مشروع قناطر اسنا الجديدة

سد الإغلاق (Closure Dam)

التغيير من التصميم الأصلي الى الحل البديل

(Alternative Solution for Closure Dam)

التصميم المعدل: (Alternative Solution for Closure Dam)

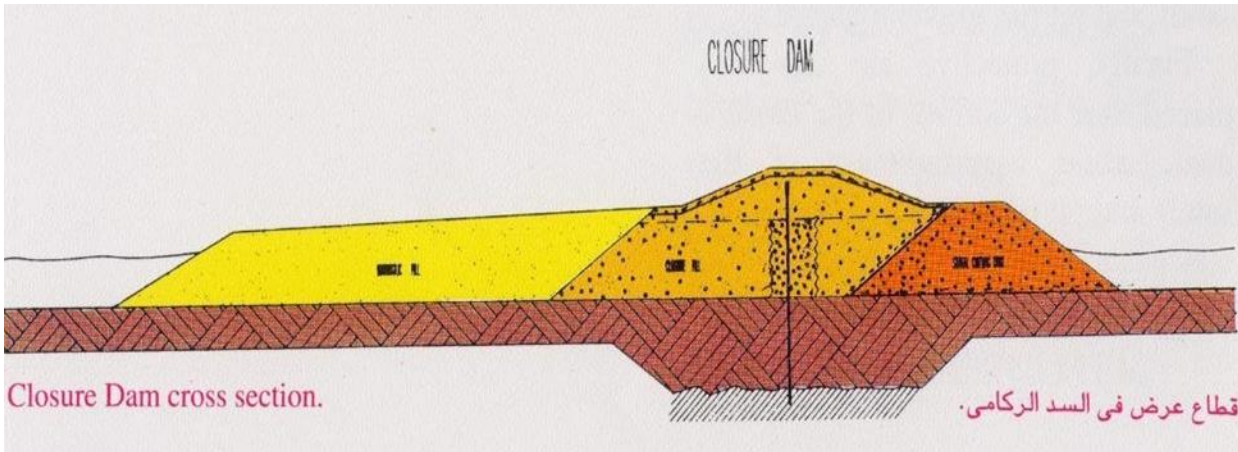
1. السد الحجري الخلفي: تم الحفاظ على القطاع تقريباً مع تغيير نوع الأحجار من (100-200 مم) إلى (50-100 مم)، وتغيير نسيج الجيوتكستايل من وزن 320 إلى 1200 جم/م² للجزء السفلي، و800 جم/م² للميل الأمامي.

2. استبدال الرمل الناتج من الحفر في تكوين جسم السد بترربة زلطية من محجر الدير (مكونة من رمل وزلط بأحجام أقل من 100 مم)، حيث ينتهي الردم عند مسافة حوالي 35 مترًا من محور الطريق عند منسوب (75.00 متر)، ثم يستمر بالانحدار الطبيعي حتى القاع.

3. إكمال الردم الأمامي باستخدام الرمل الناتج من عمليات الحفر بزاوية ميل 1:40 كما هو موضح في المقطع العرضي.
4. تكوين جسم الطريق فوق منسوب (73.00 متر) كما هو وارد في العقد باستخدام تربة مستوردة مع الدك الجيد.

5. تنفيذ نواة (core) في جسم السد حول الستارة القاطعة بعرض 10 أمتار (5 أمتار من كل جانب) باستخدام تربة مكونة من رمل وزلط (أقل من 100 مم) مع إضافة 10% من المواد الناعمة (أقل من 5 مم)، مع حقن هذه النواة بالبتونايت قبل تنفيذ الستارة. وتُعرف هذه العملية باسم Vibrogrouting.

مرفق رقم (12)

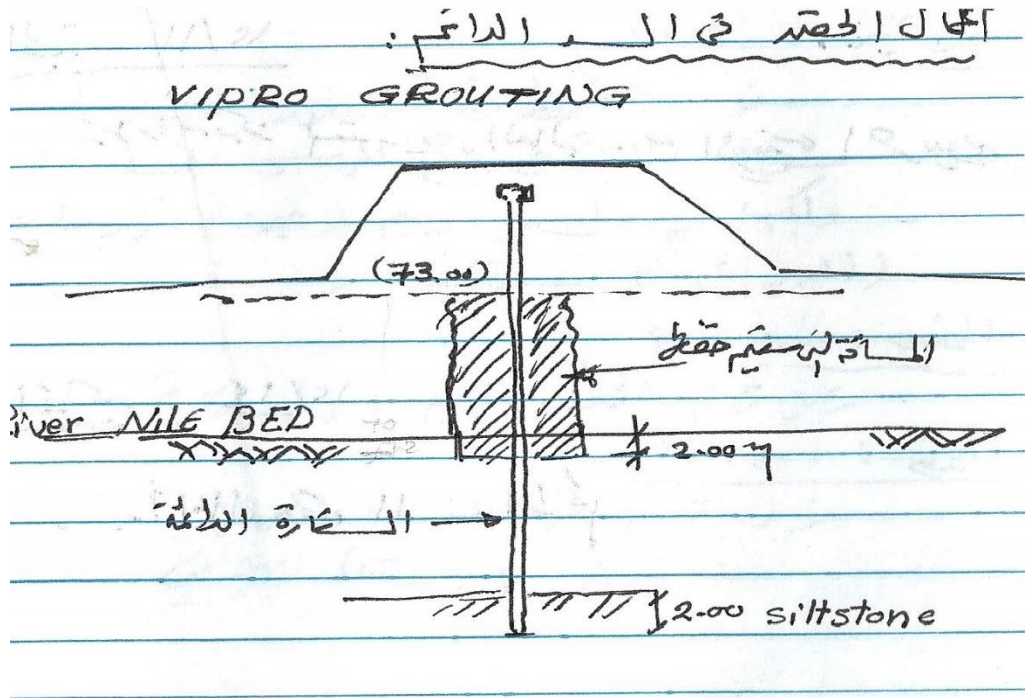
تم تنفيذ أعمال الحقن في السد الدائم على جانبي الستارة الدائمة في المنطقة الواقعة داخل النهر، لضمان عدم حدوث انهيارات أثناء الحفر في المنطقة بين سطح الماء والقاع، حيث لا يمكن دك هذه المنطقة تحت الماء. ويبلغ متوسط عمق الحقن حوالي 12 مترًا، مع الحفر إلى أسفل القاع لمسافة 2 متر على الأقل. شملت

أعمال الحقن مسافة حوالي 200 متر عند منسوب أقل من (66.00 متر)، حيث تم تنفيذ نقاط الحقن على مسافة 90 سم على جانبي محور الستارة وعلى مسافات 6 أمتار، مع التبادل بين الجانبين.

مرفق رقم (1)
التصميم الاصلى فى العقد

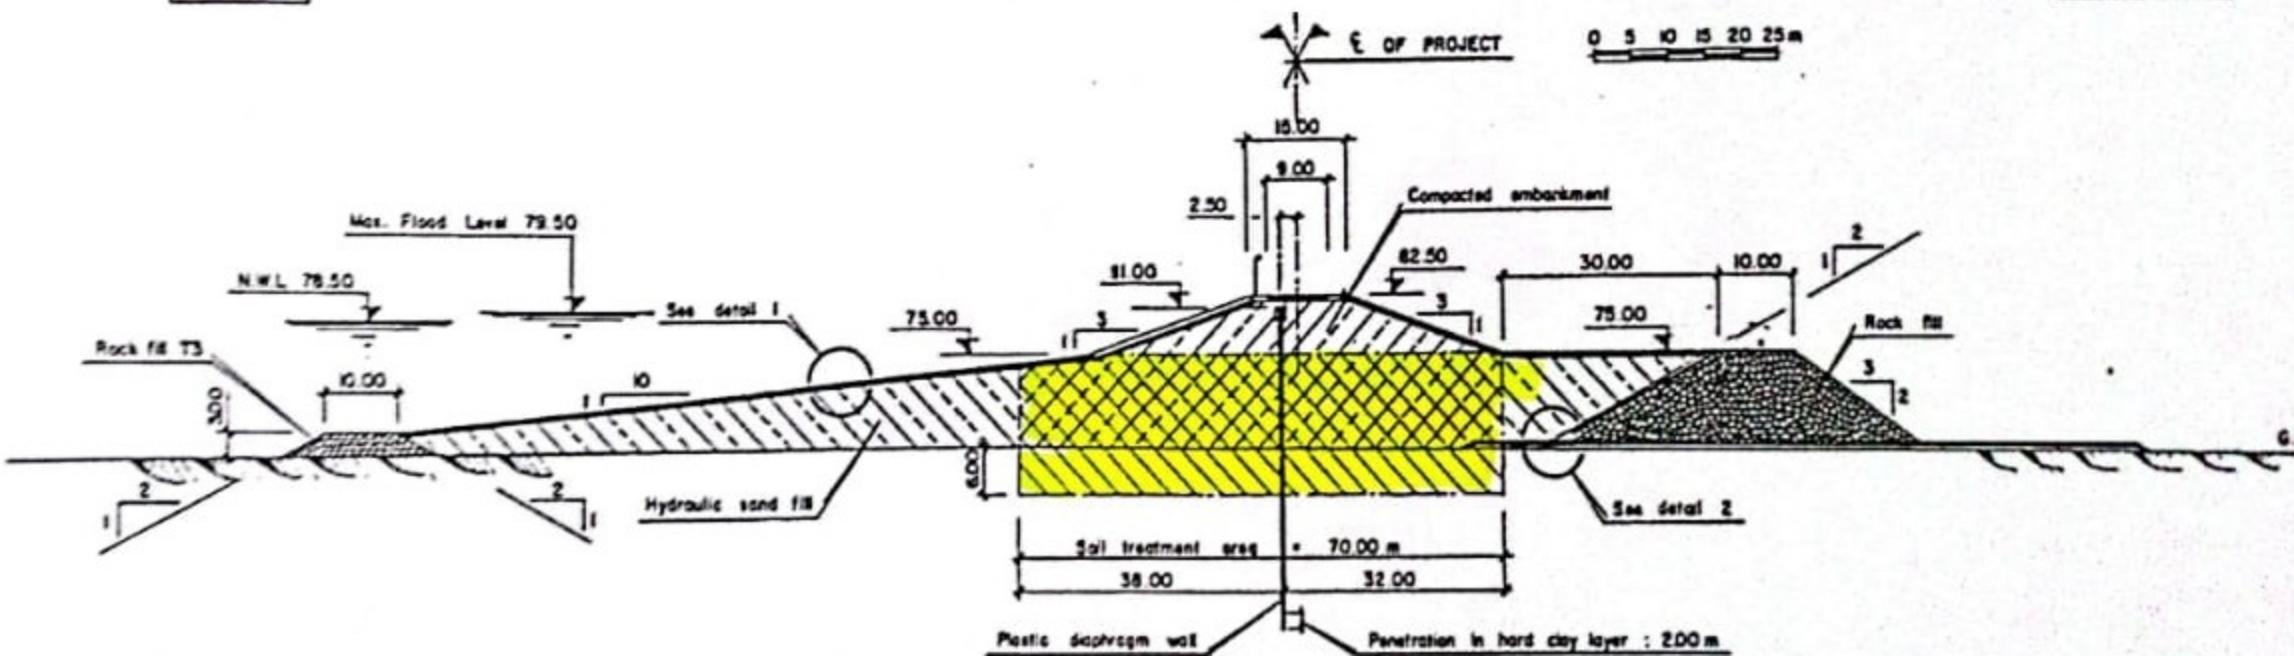
1. سد حجري خلفي يمتد من القاع حتى منسوب (75.00 متر) بعرض 10 أمتار عند القمة وبميل جانبي 2:3، مكون من أحجار النوع (100-200) B مم.
2. سد حجري أمامي بارتفاع 3 أمتار وعرض 10 أمتار وبميل جانبي 2:1، مكون من أحجار النوع 0-152 T3 مم.

3. ملء المسافة بين المنسوب العلوي للسدين الأمامي والخلفي بالرمال الناتجة من أعمال الحفر بالتكريك، مع عمل ميل من منسوب (75.00 متر) إلى منسوب السد الأمامي بمقدار 10:1.

4. دك التربة المحيطة بمحور الستارة بعرض 70 مترًا (38 مترًا من اليسار و32 مترًا من اليمين) بطريقة التعويم الاهتزازي (Vibroflotation)، وهي إحدى طرق الدك بالاهتزاز لتحسين خصائص التربة.

5. ردم جسم السد فوق منسوب (75.00 متر) حتى منسوب (82.50 متر) باستخدام تربة مستوردة من خارج الموقع مع الدك الجيد، بعرض 15 مترًا من الأعلى وبميل جانبي 3:1.

6. تنفيذ ستارة قاطعة دائمة من الخرسانة البلاستيكية (Permanent Diaphragm Wall) في محور السد، تمتد حتى تصل إلى الطبقة الطينية الصماء لمسافة 2 متر، وترتفع حتى منسوب (80.50 متر) من الأعلى.

Fig. 4/3 New Esna Barrage. Critical surfaces investigated for the preliminary assessment of the overall safety factor of the proposed cross section.

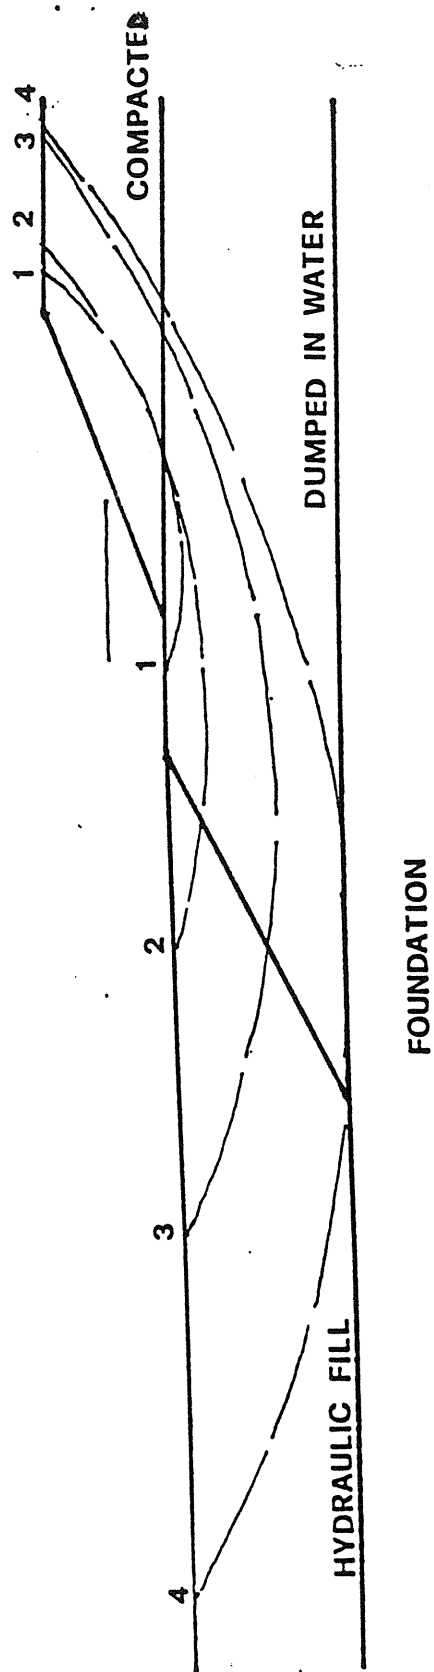
Preliminary stability analyses of the upstream slope have been carried out considering 4 families of slip surfaces as shown in Fig. 4/3. Each critical surface was identified analysing 10 slip circles with Modified Bishop's Method. The above analyses lead to the following factors of safety:

elc electroconsult milano Italia	DATE	SCALE	CHECKED	DRAWN
TITLE: CLOSURE DAM LEFT ABUTMENT - 1 STAGE PLAN AND DETAIL	MAY 91	1:500		
	DRAW. N°			
	ELC-046

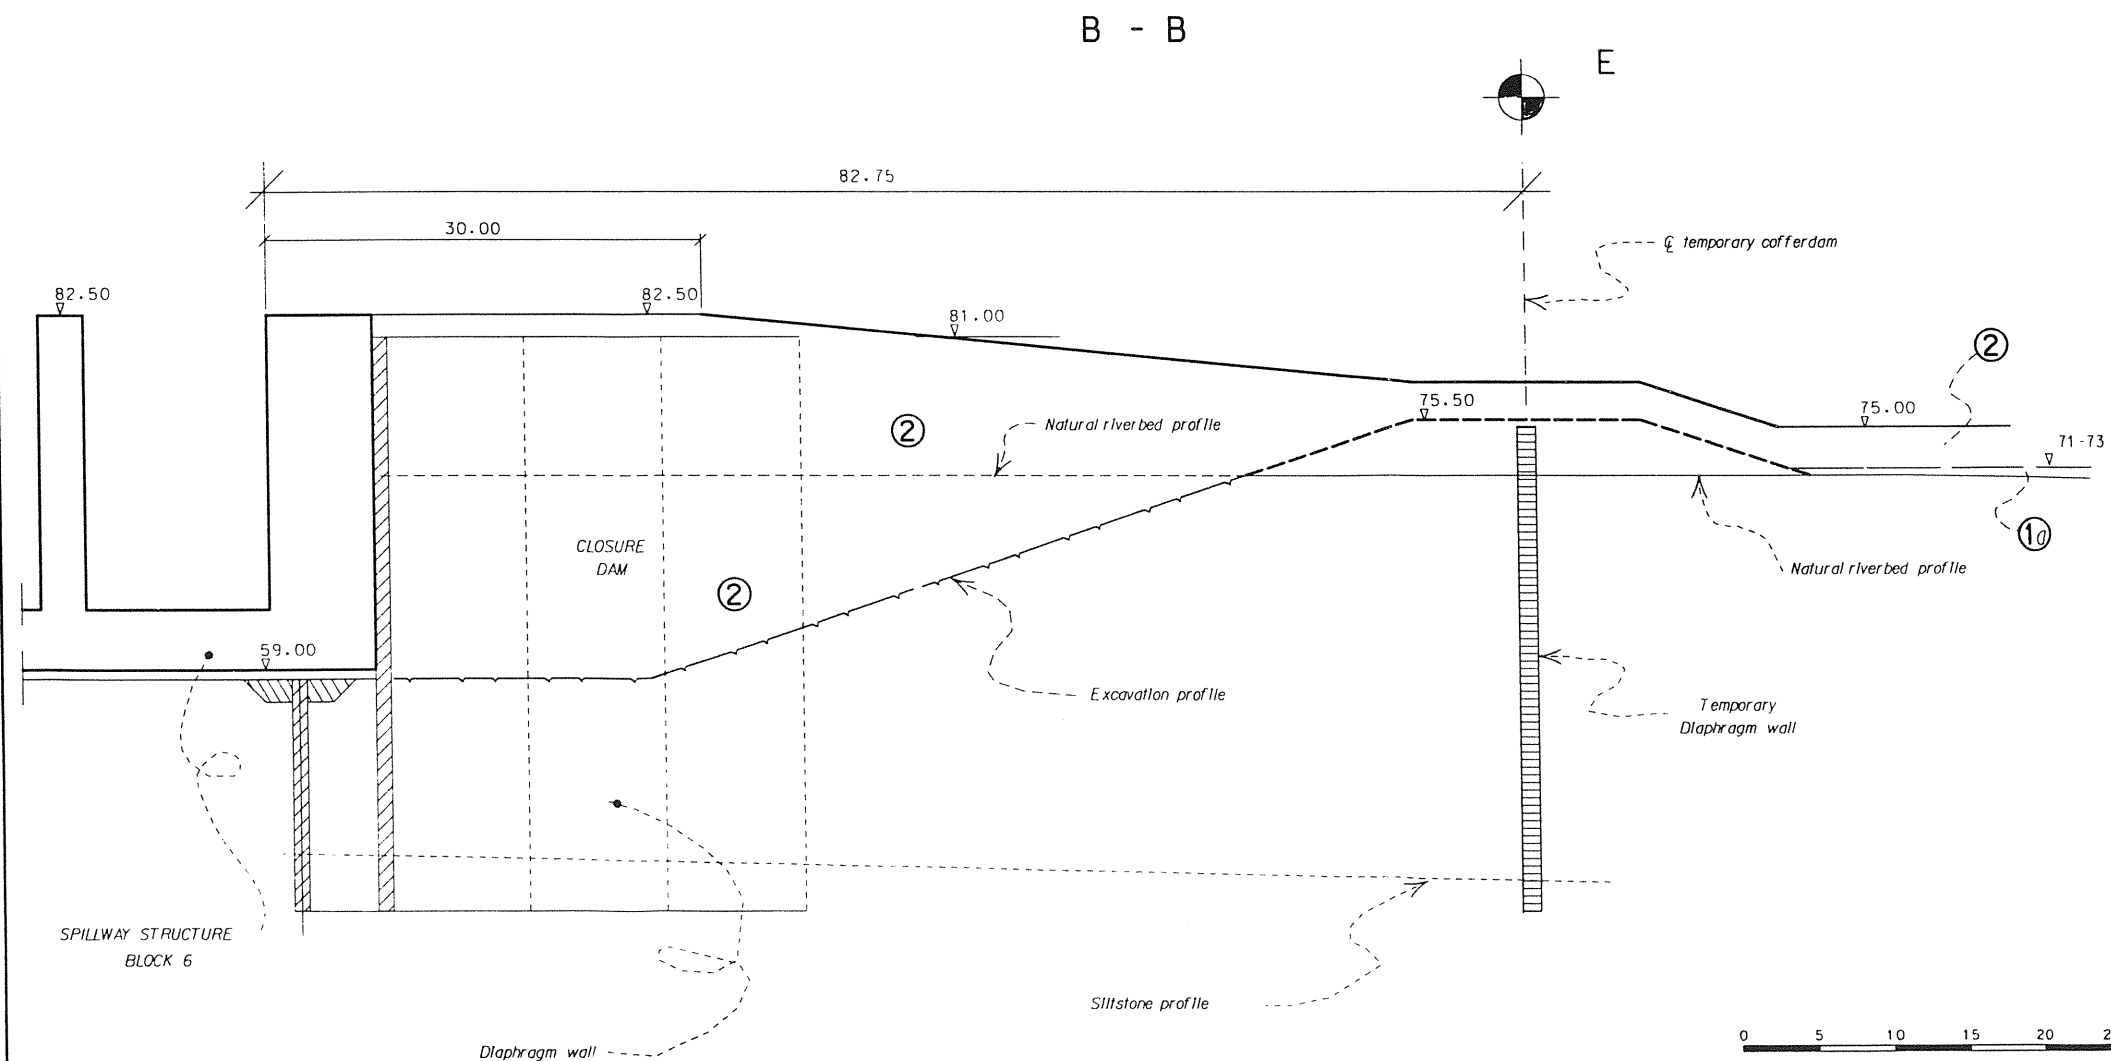
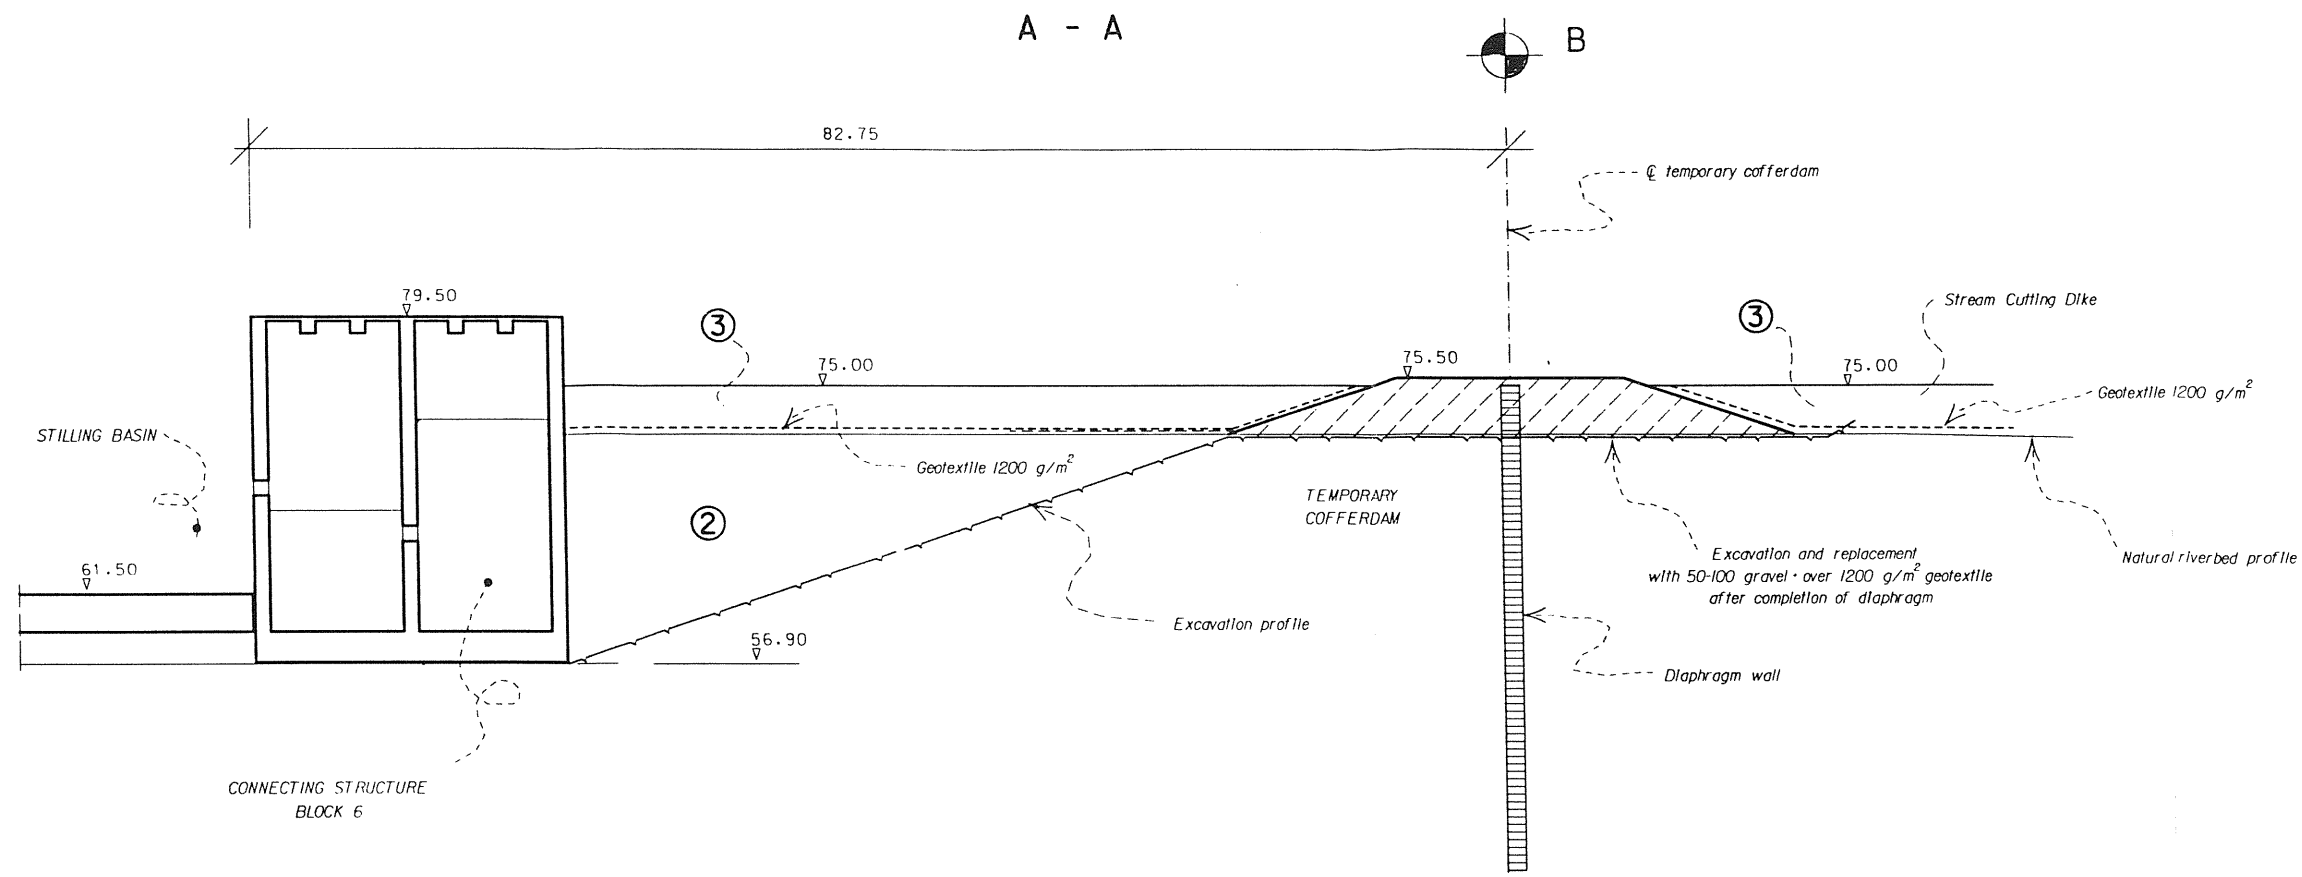
As shown on the enclosed drawing ELC-046 a special contact arrangement, including 1 or 2 diaphragm panels placed crosswise, and a recessed waterstop are recommended to be provided against the spillway end block. The concrete end block will be shaped so as to allow an easy excavating of the contact panels and to produce a geometry favouring a progressive confinement of the fill downstream from the cut-off, under the action of consolidation and downward movements induced by the hydrostatic forces. The end block geometry will also be such as to make the hydrostatic pressure increase the effective pressure along the diaphragm-spillway pier contact surface thus making the seal more effective.

A 0.35 m wide, rubber waterstop will be installed in a recess which will be filled with clean sand as the fill for the dam is raised. The excavation of the end panel of the cut-off wall should completely remove the sand from the recess allowing it to be filled with plastic concrete at casting time.

As an extra precaution, a 3.0 x 3.5 m zone of the fill will be made with sand and gravel scalped at 25 mm and added with 5% powdered bentonite to form a more plastic and less pervious plug. The contact between plug and concrete wall will be made with a mix of sand (<2 mm) and bentonite (10% by weight), moderately wetted and compacted in 0.1 m layers by hand tampers. The sand and bentonite mortar shall be 0.1 m thick.
